We have received the attached Federal Emergency Management Agency (FEMA) letter dated April 25, 1985, and associated evaluation of the Alert and Notification System for the Monticello Nuclear Generating Plant in Monticello, Minnesota.

The Federal Emergency Management Agency (FEMA) has completed an analysis of the prompt alert and notification system for the Monticello Nuclear Generating Plant in Monticello, Minnesota. This review has been completed pursuant to FEMA rule 44 CFR 350; selected evaluative criteria and Appendix 3 in NUREG-0654/FEMA-REP-1, Rev. 1; and FEMA-43, the "Standard Guide for the Evaluation of Alert and Notification Systems for Nuclear Power Plants." The enclosed report entitled "Monticello Nuclear Generating Plant Site-Specific Offsite Radiological Emergency Preparedness Alert and Notification System Quality Assurance Verification," summarizes the engineering design review, incorporates the results of the telephone survey of the public conducted immediately following the alert and notification system activation on October 3, 1984, and includes the results of the review of the other applicable evaluative criteria from NUREG-0654/FEMA-REP-1, Rev.1, and FEMA-43.

FIGURE 4

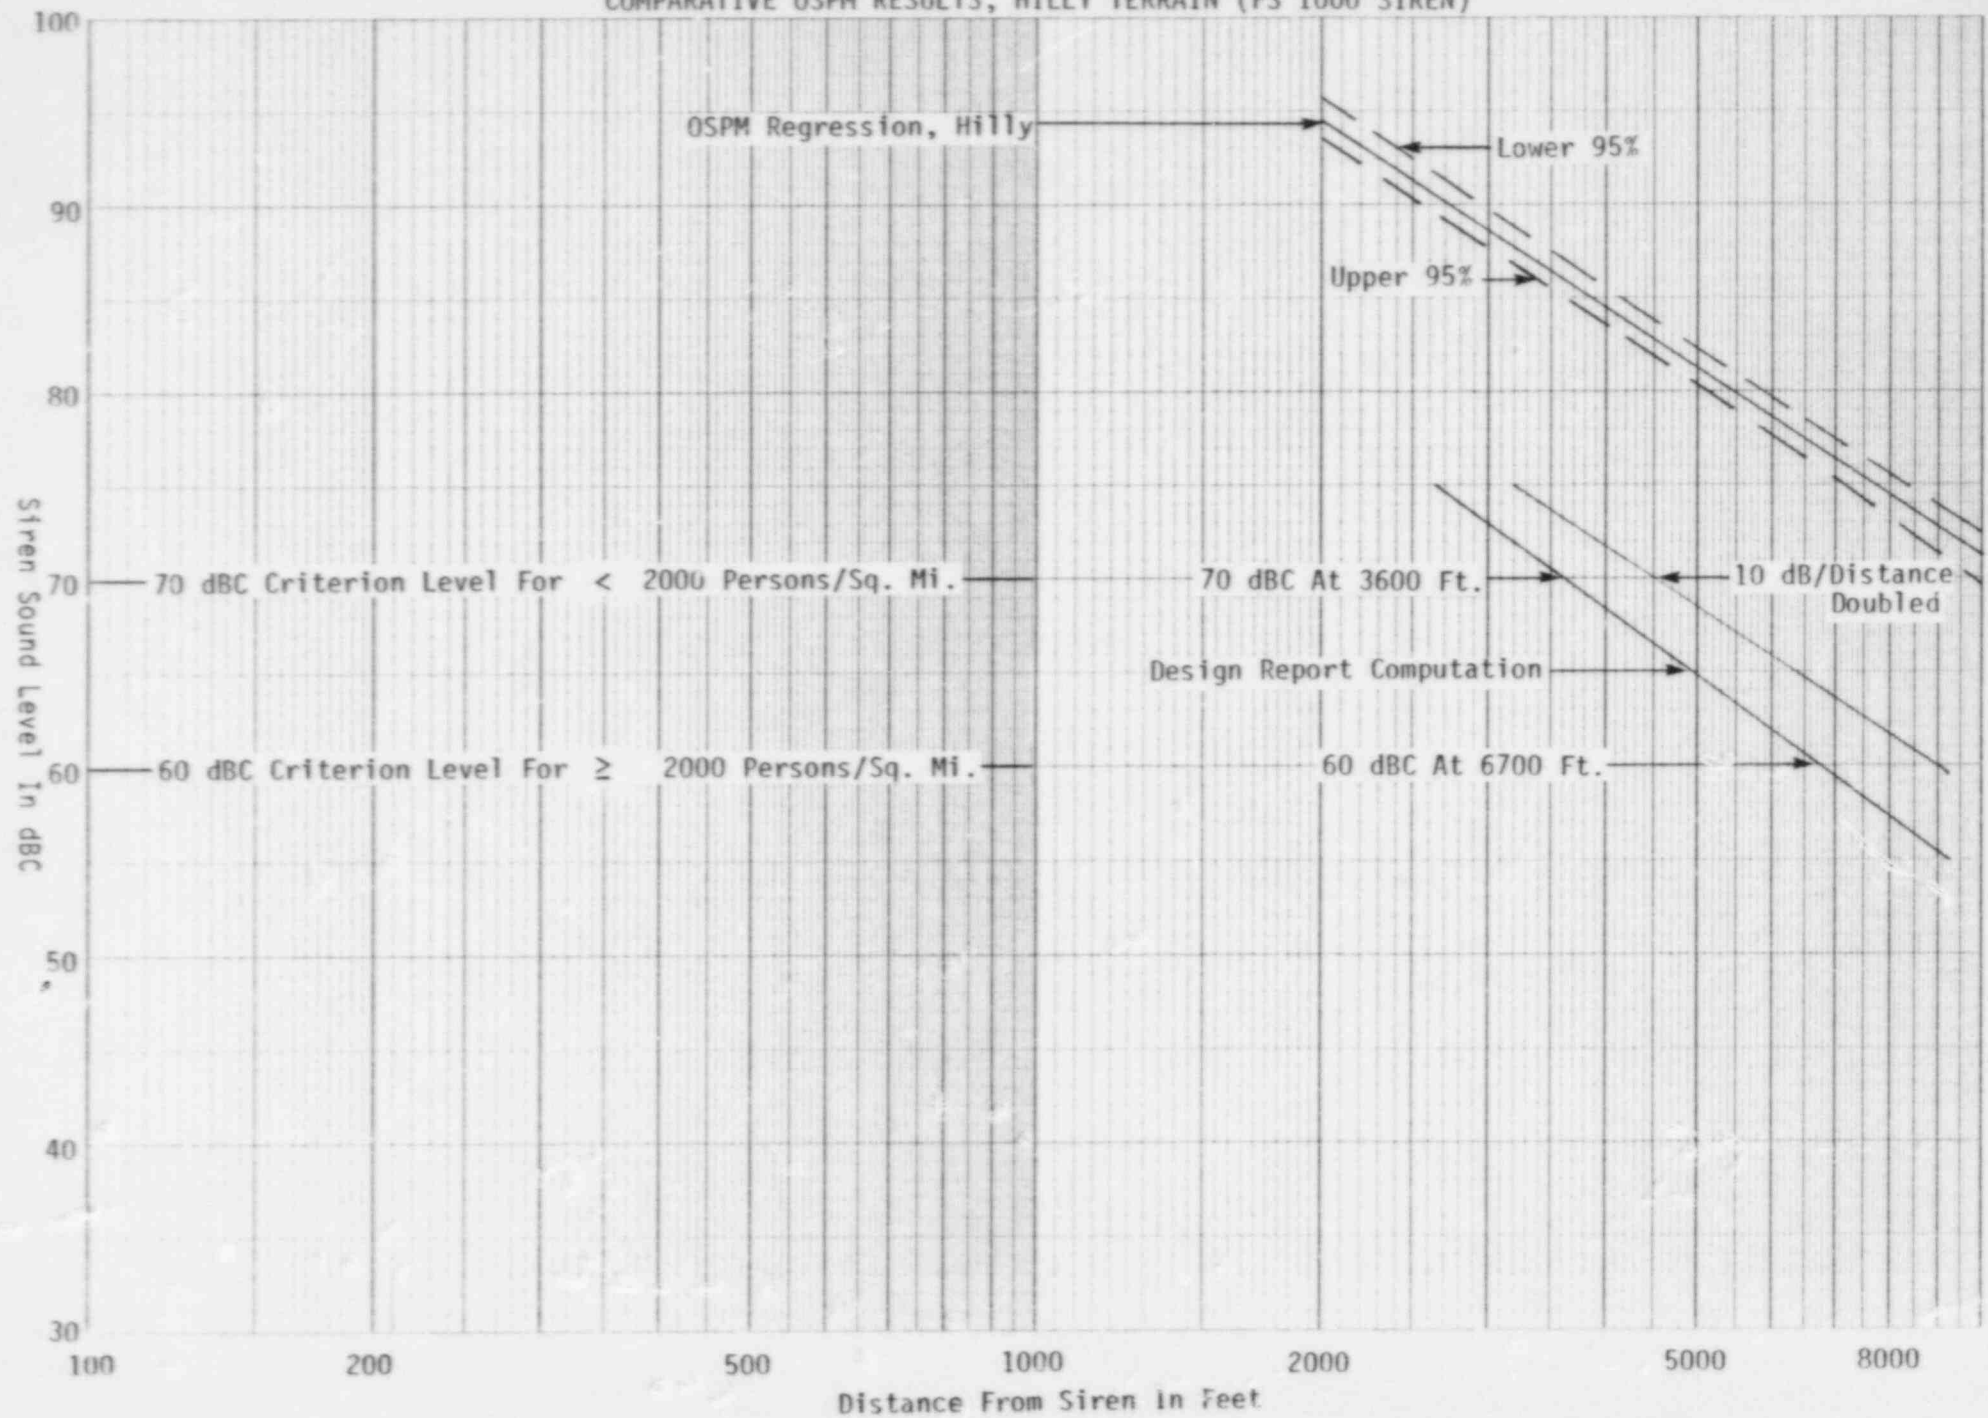
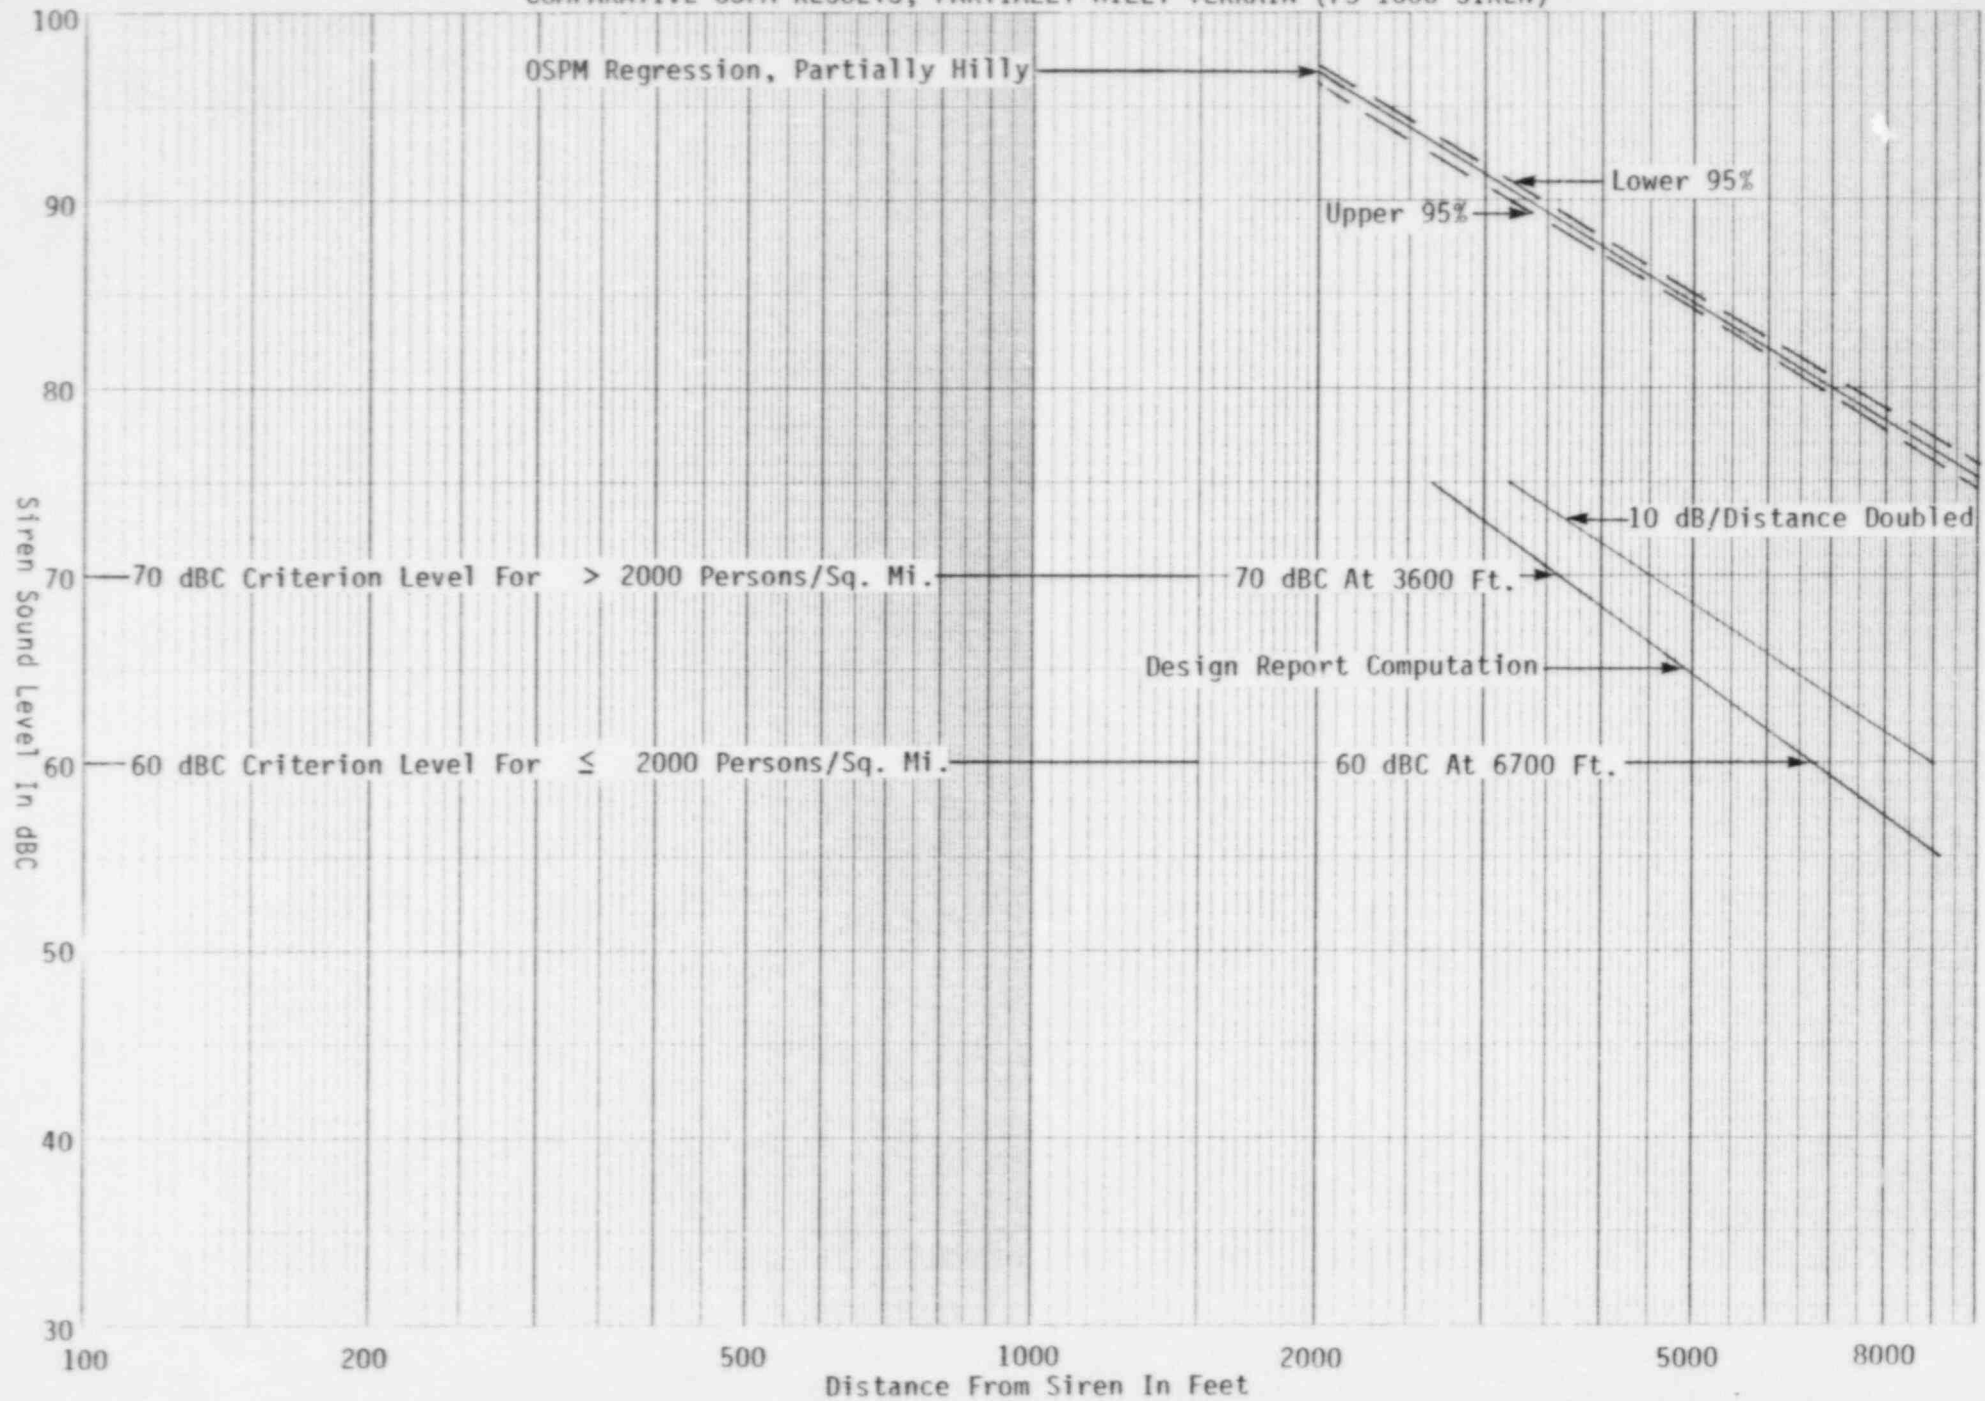
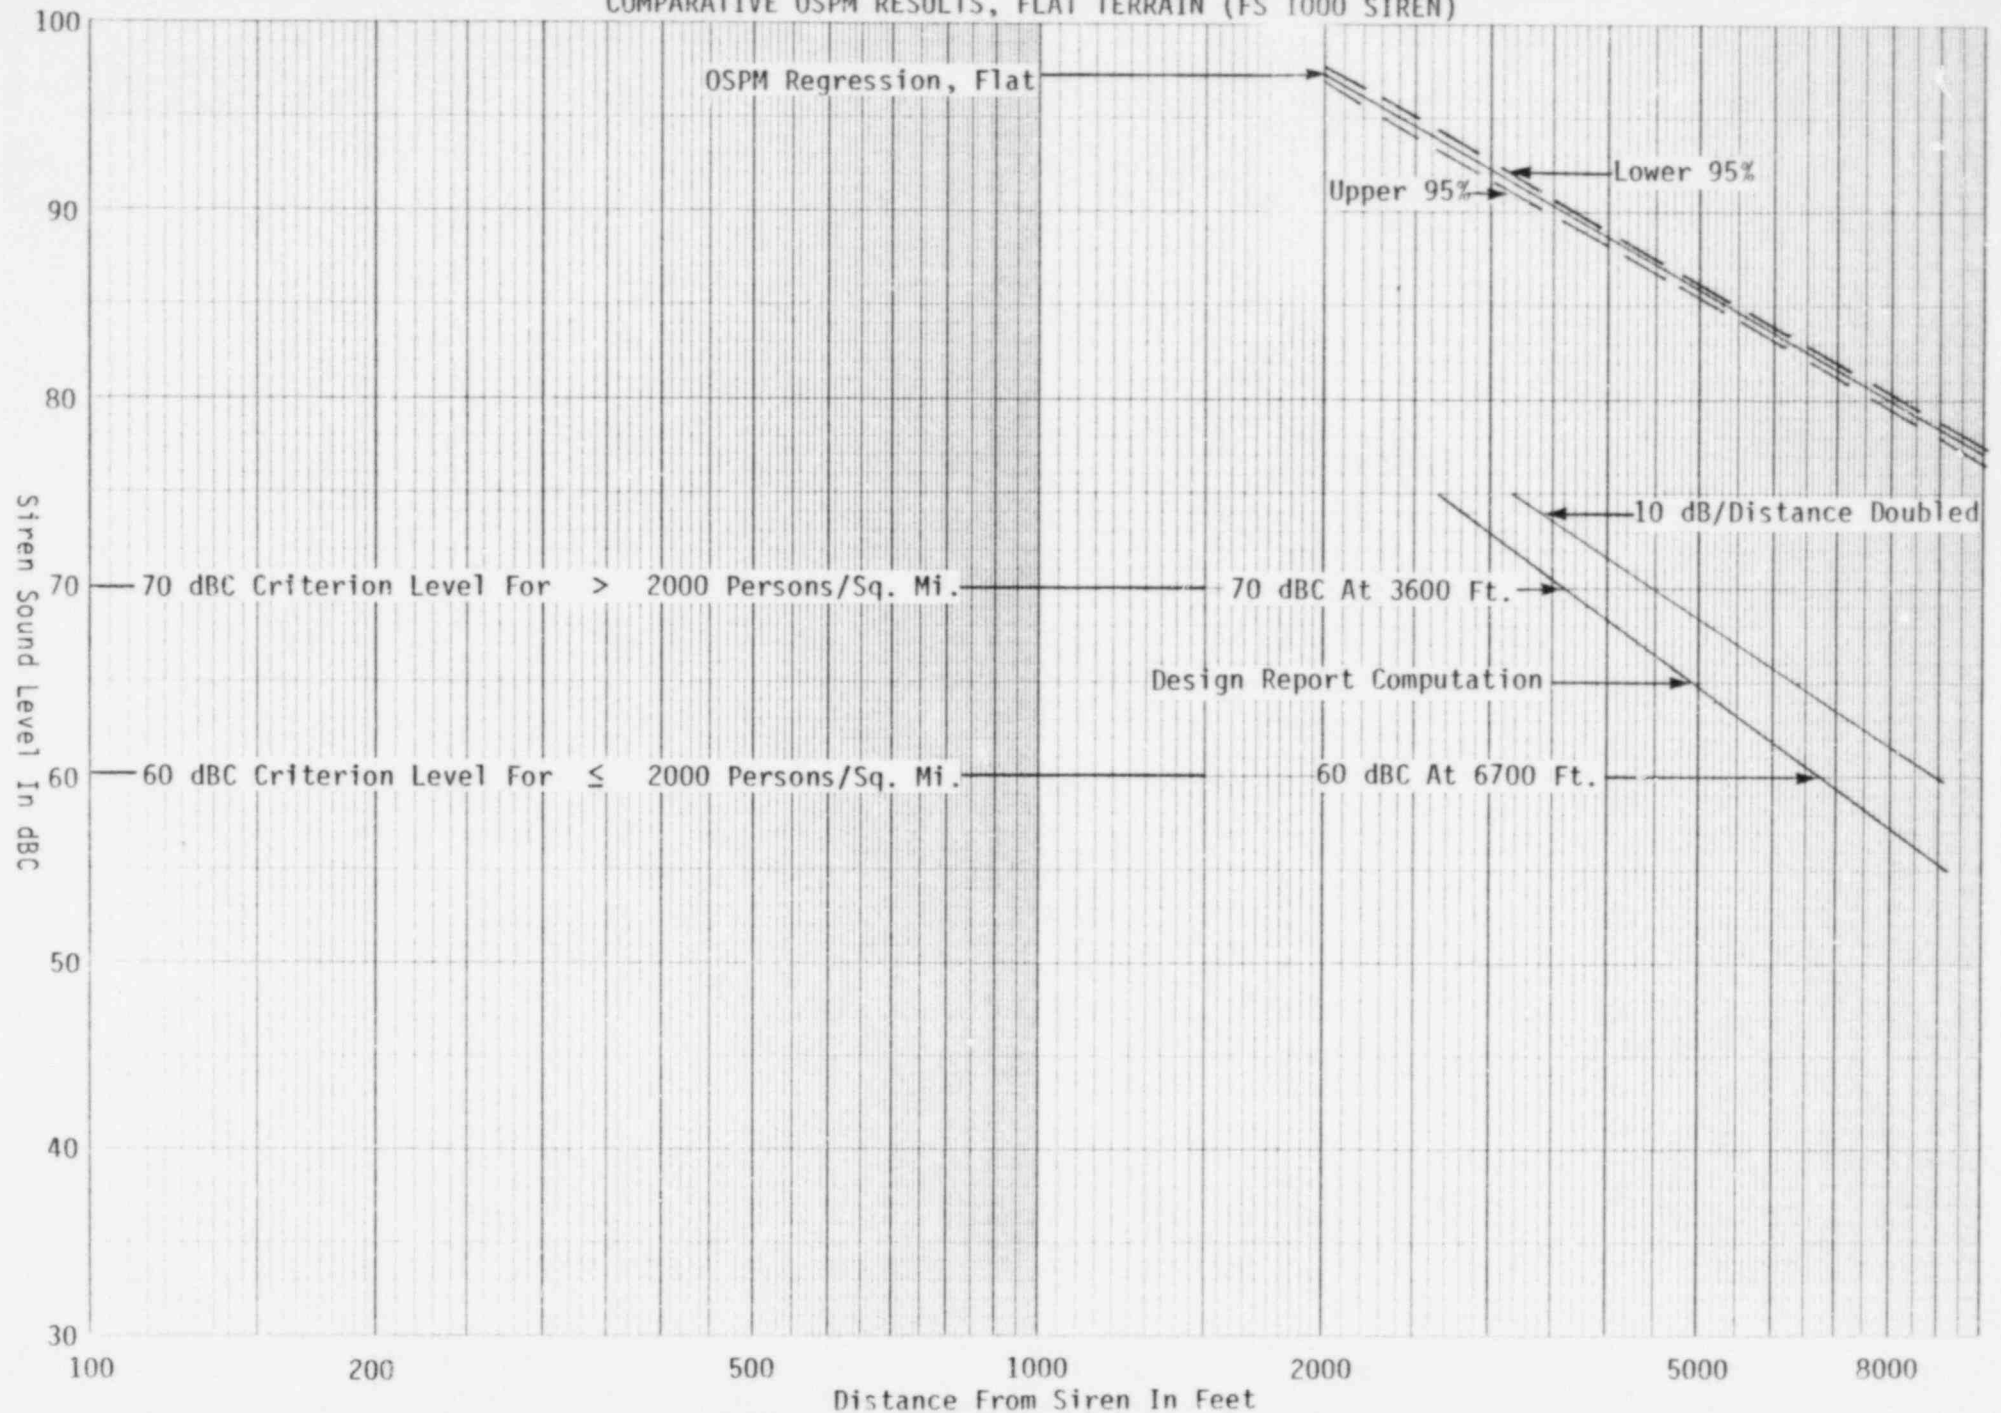
The results of the individual OSPM runs were combined to generate a comprehensive overview of the siren sound pressure levels over both the Monticello and Buffalo areas as depicted in Figures 2 and 3. A surface interpolation and contouring program utilizing the output results of the 14 sirens was used to generate the sound pressure level contour overlays. These contours account for site-specific topographical and meteorological effects. Comparisons of the OSPM predicted 70 dBC and 60 dBC

contours with the contours in the Wyle Report (Map 1) indicate that the siren coverage as calculated in the Wyle Report is very conservative in the Buffalo and Monticello areas and similar to OSPM results in hilly terrains.\*

The design procedure results in a reasonably conservative overall estimate of Monticello Nuclear Generating Plant's siren warning system coverage and is found to be adequate in satisfying FEMA-43 specific design requirements.
